Illinois Pollution Control Board
RE: PCB 08-42
100 W. Randolph St., Suite 11-500
Chicago, IL 60601

To the Illinois Pollution Control Board Regarding Case PCB 08-42:

I. Landfill Capacity

PEORIA DISPOSAL COMPANY PEORIA, ILLINOIS	
DEVELOPMENT PERMIT APPLICATION	AREA C
FINAL COVER PLAN	
HARZA ENVIRONMENTAL SERVICES, INC. APPROVED: <i>[Signature]</i>	
CHICAGO, ILLINOIS	DATE: MAR 1986 DRAWING NO.: 1517H 08

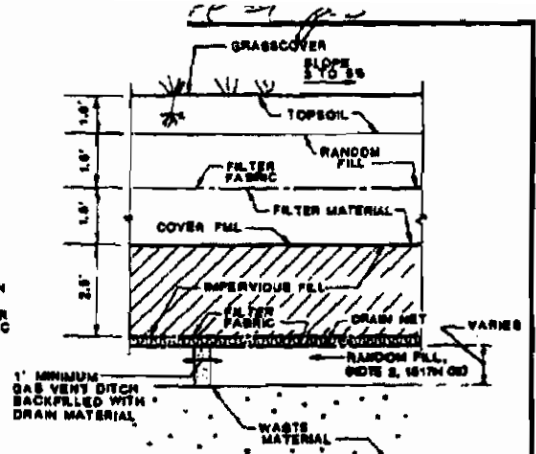
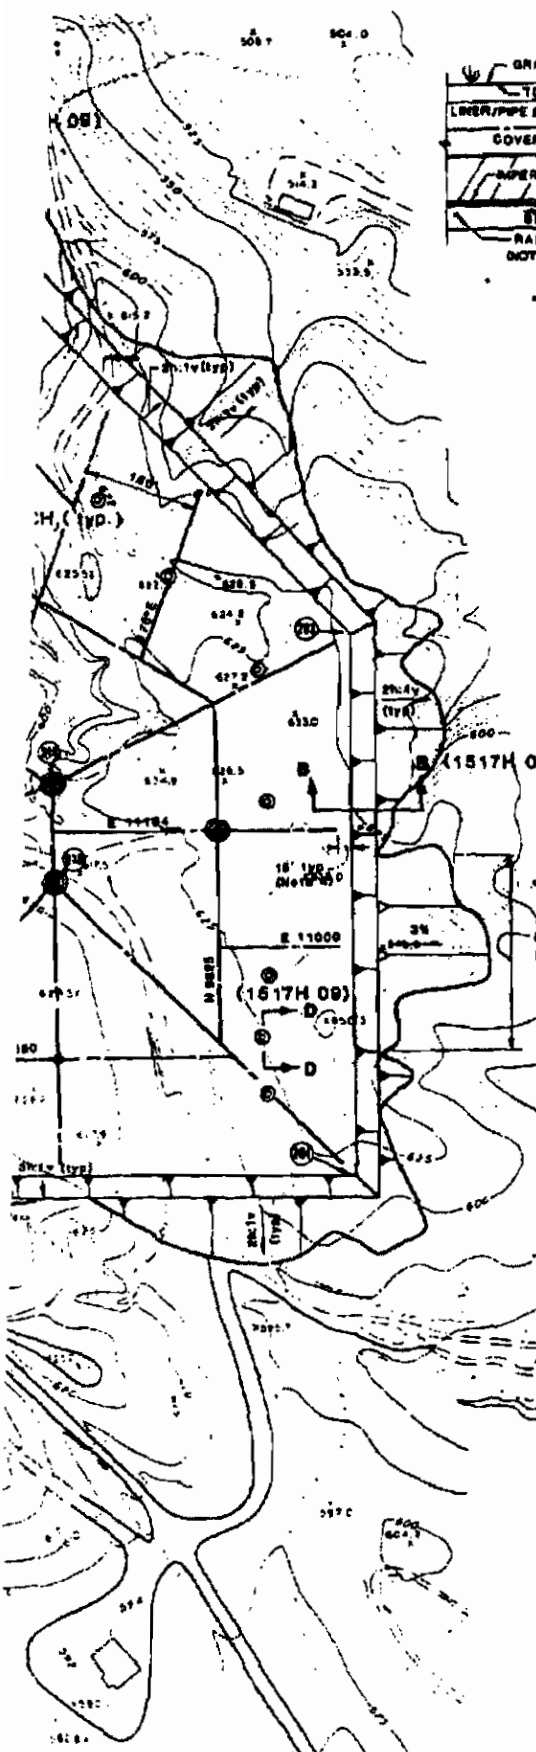
HOI asks the IPCB to review the “calculated redesign” of the landfill height, weight, and slopes over Cell C1 in particular, and over Cells C2-C4 to verify that the additional load and increased slopes are protective of the public health and safety. The steepest slopes with 4 to 1 raise are at the south edge of the landfill closest to Pottstown, and in proximity above the Peoria Dog Obedience Training Club on Southport Road.

Figure 25 Cross-section B-B' along east side of Peoria Disposal Company site.

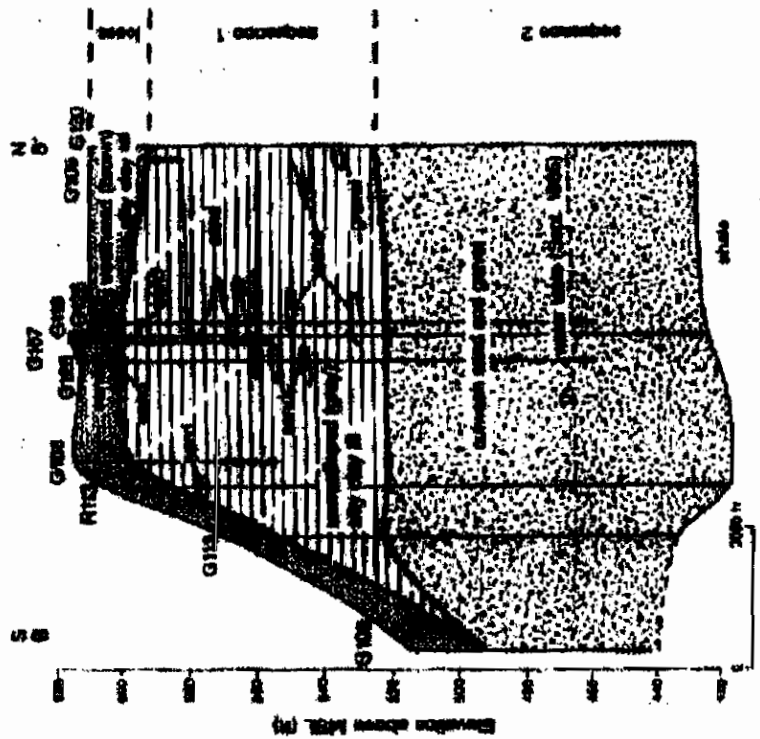
Aquifer level sands below the PDC waste site link to the Sankoty aquifer, which supplies water for Peoria and outlying communities. It is well documented that sand lenses occur on the east side of the landfill,⁶ and that two large sand lenses were encountered in the excavation of Cell C-1.⁷

6 Exhibit 6, Herzog et al, Evaluation of Groundwater Monitoring Programs at Hazardous Waste Disposal Facilities in Illinois (1988), Figure 25, "Cross-section B-B' along east side of Peoria Disposal Company site"

Exhibit #7

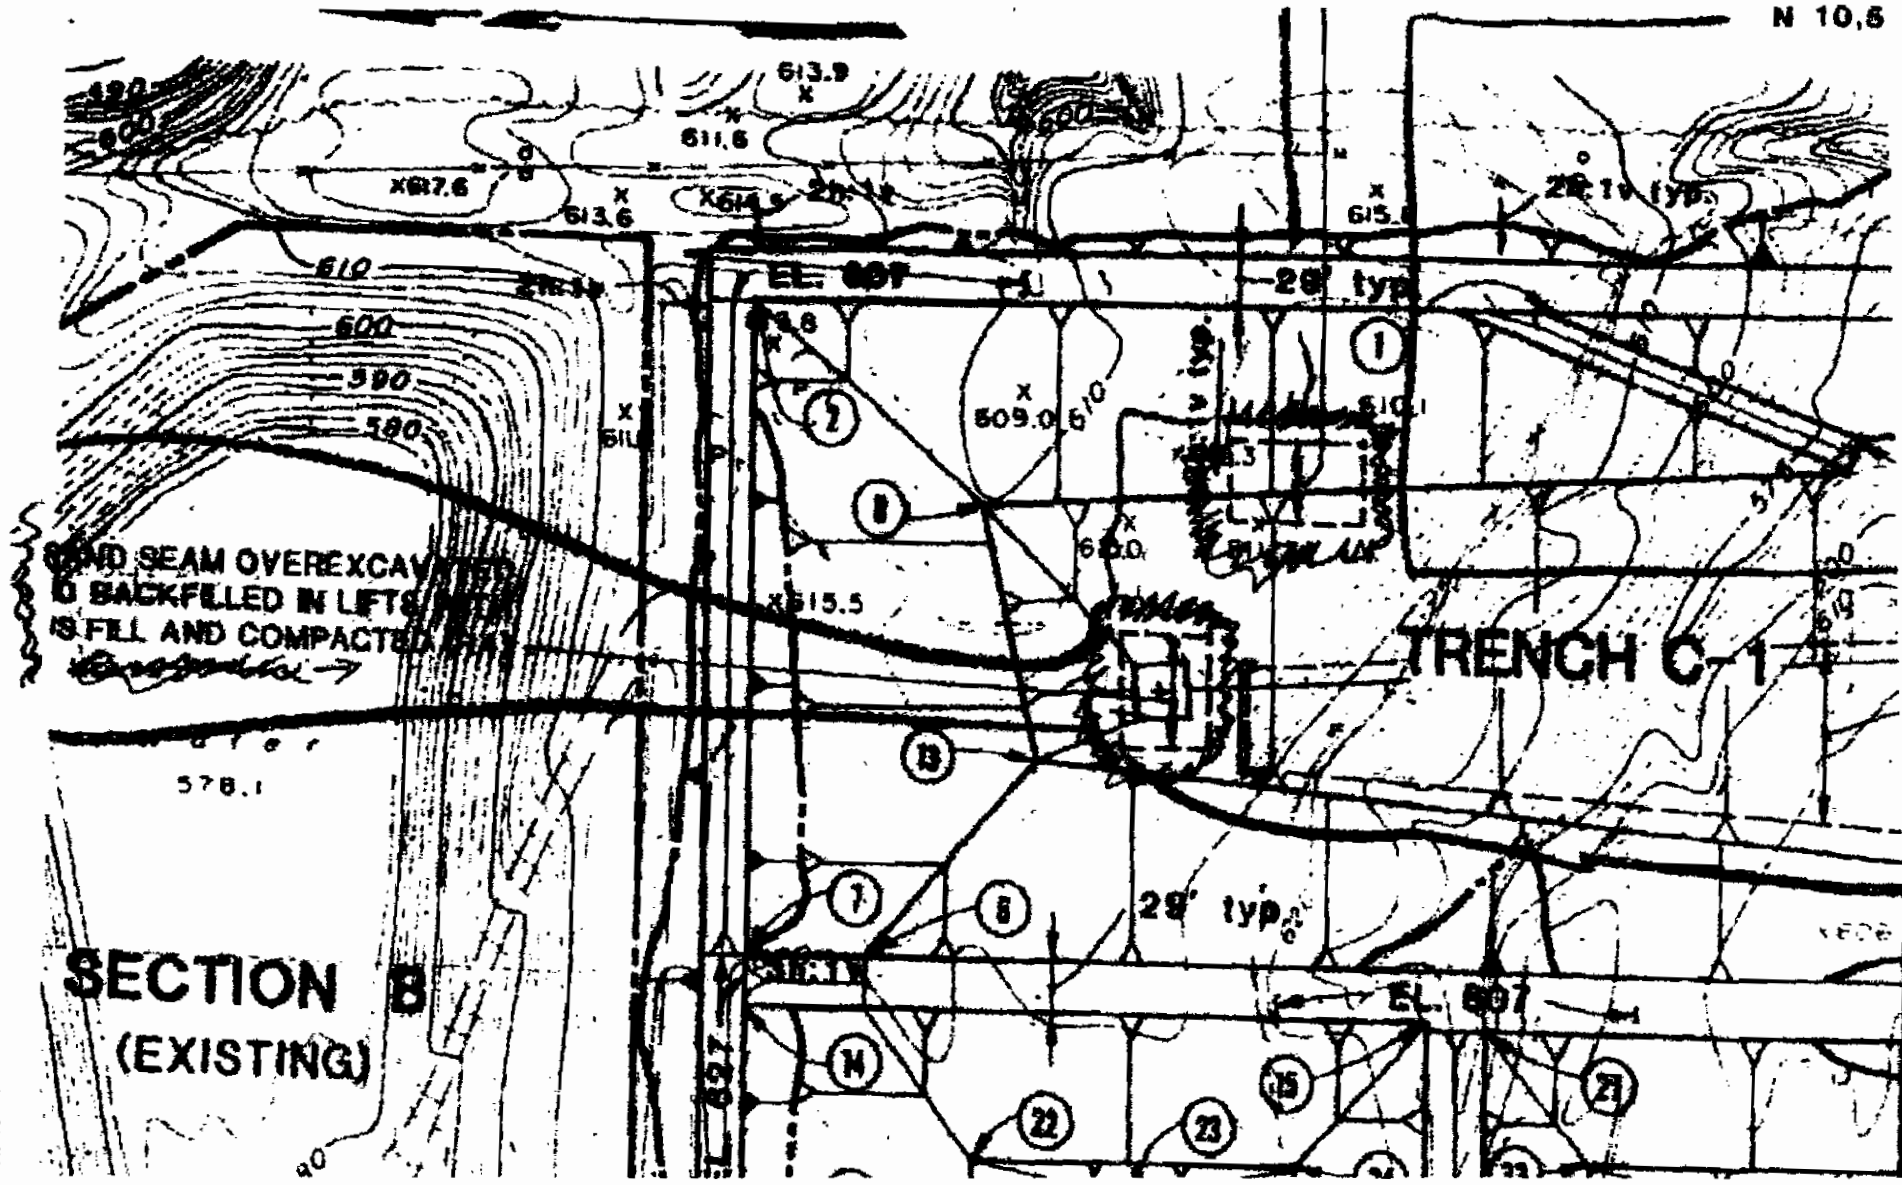
7 Exhibit 7, Trench C-1, "Sand Seam Overexcavated ..." trench drawing
